Report to Development Permit Panel

DP 21-942090

Application by Sian Group Investments Inc. for a Development Permit at

7100 and 7120 Ash Street

PLAN # 2.a August 24, 2022 DP 21-942090

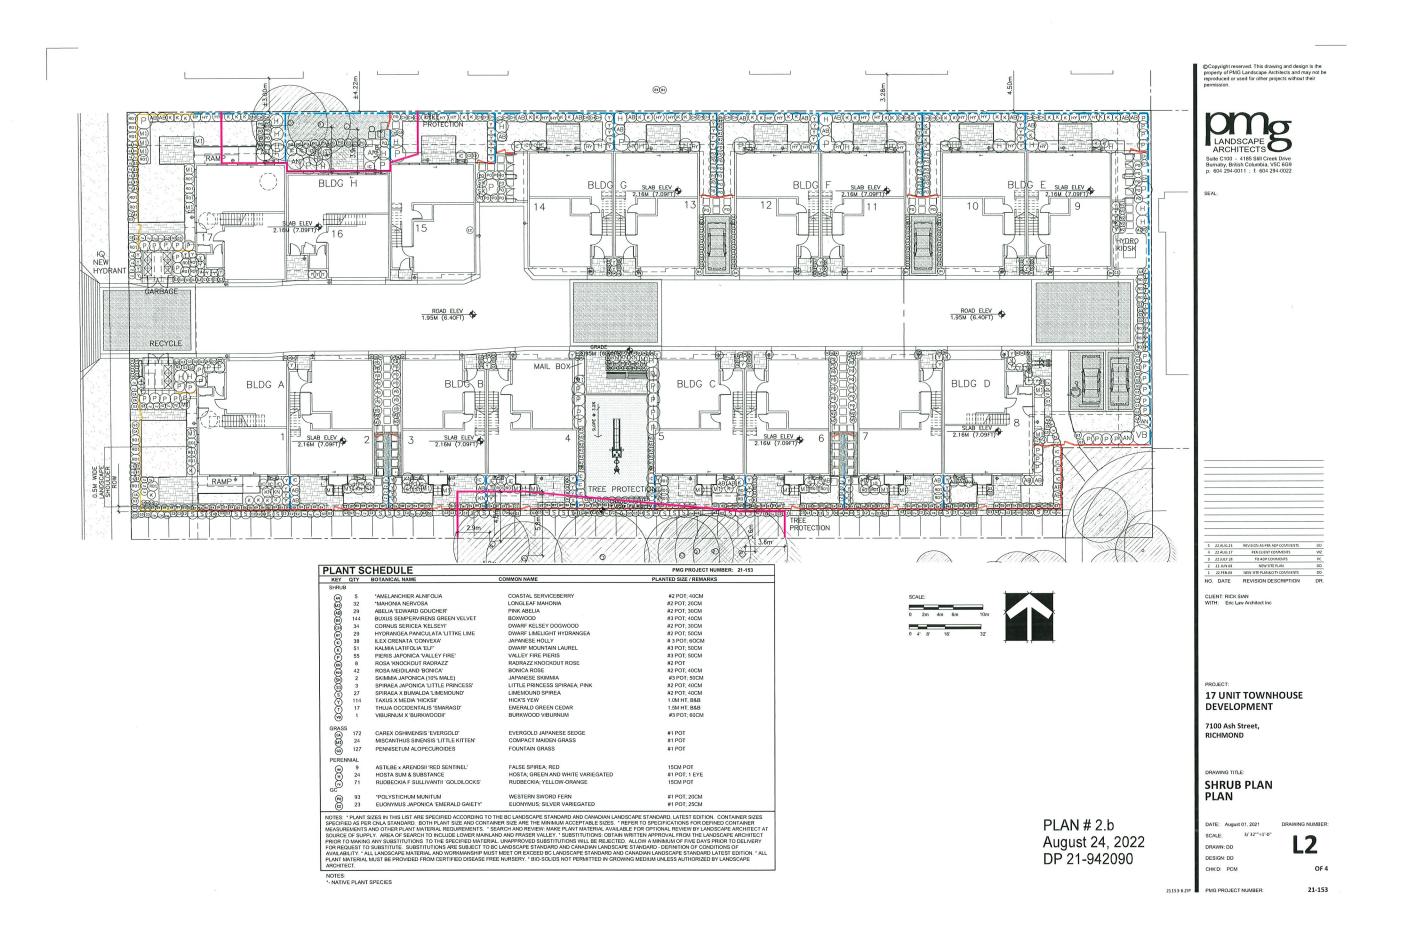
- consider a more passive use for the common outdoor amenity area due to its proximity to residential units; A simple seating area and a modest children's play equipment piece are proposed. We believe further simplification will reduce the utility and interest of the outdoor amenity.

- note that the proposed surface material for the children's play area is not fully accessible: Rubber play surfacing tile is proposed to increase the accessibility of the play area.

- understand the intention for municipal collection/pickup of garbage and recycling in the proposed development; the proposed location and architectural expression for the accessory buildings for garbage and recycling are appropriate, e.g. blank façades and darker colours make them appear less prominent; the open trellis on top of the accessory buildings makes sense from a ventilation perspective; Landscape screening is also provided to minimize the visual impact of the garbage enclosures. Evergreen hedging (Taxus x media 'Hicksii') and broadleaved evergreen shrubs (Pieris sp.) are used.

- consider lowering the height of the 6-foot and 5-foot high solid wood perimeter and privacy fencing to allow more sunlight into the proposed development and residential units; The fencing between yards is lowered to 4' height to allow greater light penetration and to maintain a boundary between yards. Along south-facing sideyards, the gate and fence detail is a picket fence. This will allow light and air movement more effectively than a solid fence. The perimeter fencing at 6' is consistent with the privacy fences in the neighbourhood, especially that which separates the existing project to the north. With this precedent we believe will come the expectation of a same or similar height privacy separation between the already-constructed townhouse backyards, and our newly-proposed backyards.

PLAN # 3.h August 24, 2022

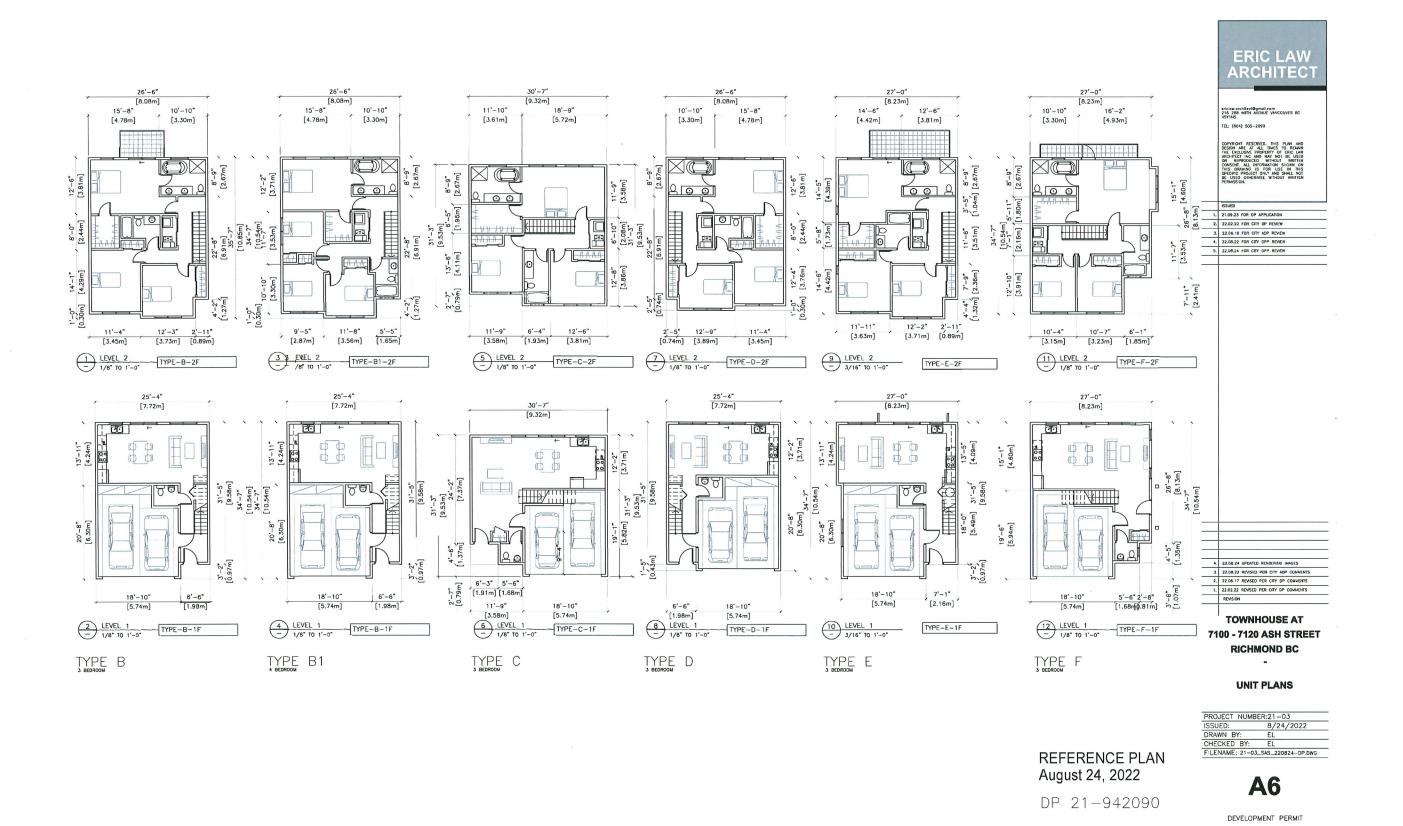
- appreciate the presentation of the project; *Noted*
- the proposal is well put together; appreciate its clarity and simplicity; *Noted*
- note the inconsistencies on the renderings presented to the Panel, in particular on the 3D images; The 3D images have been updated to rectify the inconsistencies
